## NOTICE OF AMENDMENT

**CPF 5-2010-5020M**

On July 31, 2009, a representative of the Pipeline and Hazardous Materials Safety Administration (PHMSA), pursuant to Chapter 601 of 49 United States Code, inspected ExxonMobil's procedures for operations and maintenance of Breakout Tank TK-002 in the ExxonMobil Refinery in Billings, Montana.

This letter is in response to the June 8, 2010 Notice of Amendment (NOA) from Pipeline and Hazardous Materials Safety Administration (PHMSA), concerning the July 31, 2009 inspection of the ExxonMobil Billings Refinery Breakout Tank 002 and subsequent review of the procedures for operations and maintenance of the tank.

Cathodic Protection Resurvey - Jan. 2000

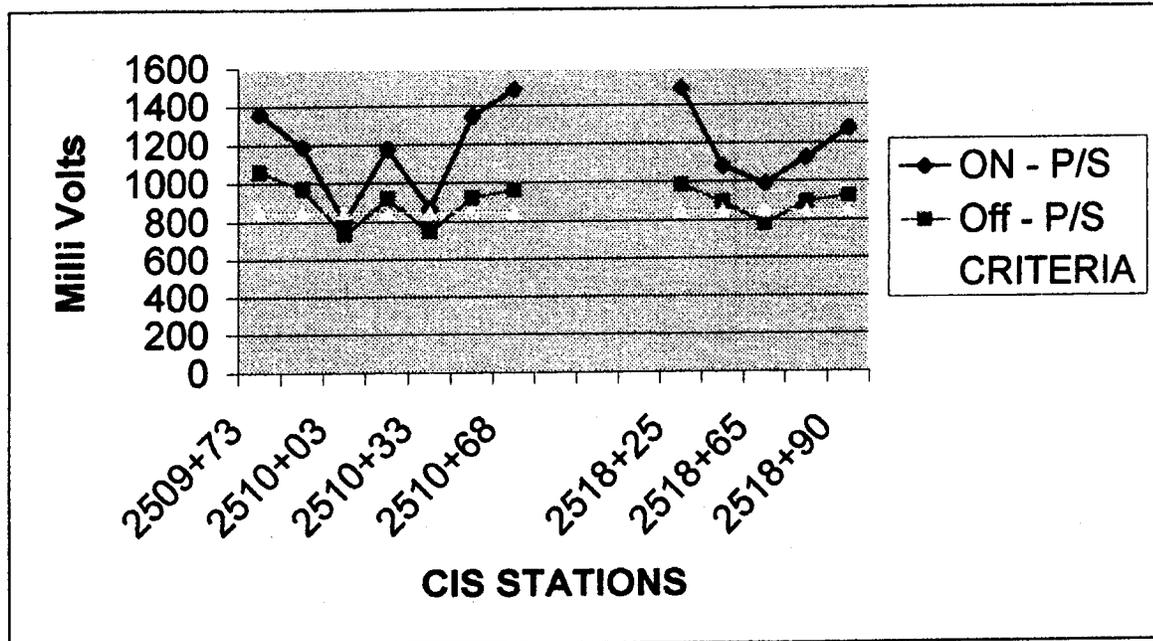
2549+ was very low for CIS  
and remains low for followup  
Need what Exxon Mobil  
did to fix this.  
(MP 68.2)
